PORT HURON HOSPITAL 1001 Kearney Street Port Huron, Michigan 48060

17 December 1984

RE: Request for amendment to NRC License No. 21-20137-01.

FACILITY DIAGRAM

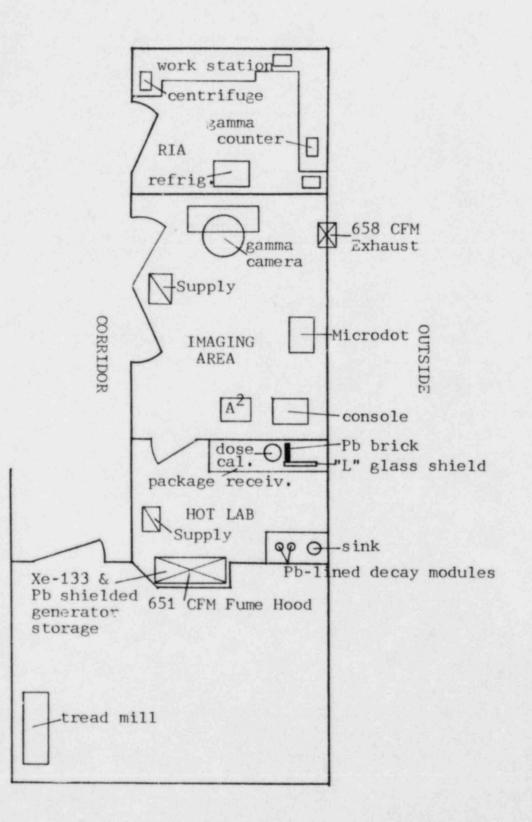
1. Change in location of our Nuclear Medicine Department. Item 11 provides a diagram of the location. Item 21 (included) provides pertinent information for Xe-133 use. A decontamination survey of the old facility is provided.
